CLEPA/OICA comments to Japan proposal to regulate LKAS and PAS

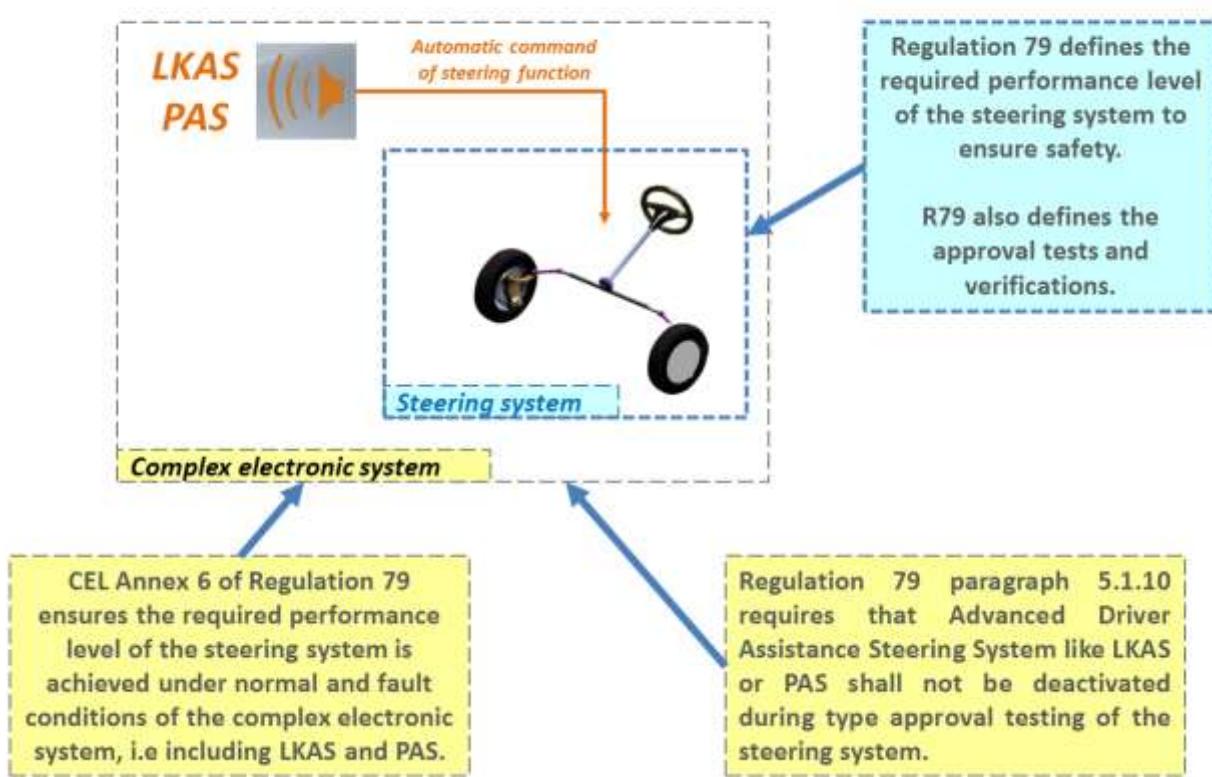
3. LKAS and PAS are two functions potentially able to generate continuous control action in order to assist the driver in following a particular path, in low speed manoeuvring or parking operations. The possible risks created by these two functions are already covered by the current text of UN R79, for example through the CEL annex. Based on UN R79 provisions, OICA believes it is secured that LKAS and PAS cannot have negative impact on safety, and that the driver can, at all times, choose to override the assistance function by deliberate action, thus remaining at all times in primary control of the vehicle.
Yet OICA is ready to contribute to a debate at GRRF level for assessing how much UN R79 is appropriate with regard to the LKAS and PAS as "Automatically commanded steering function" (see drawing below).
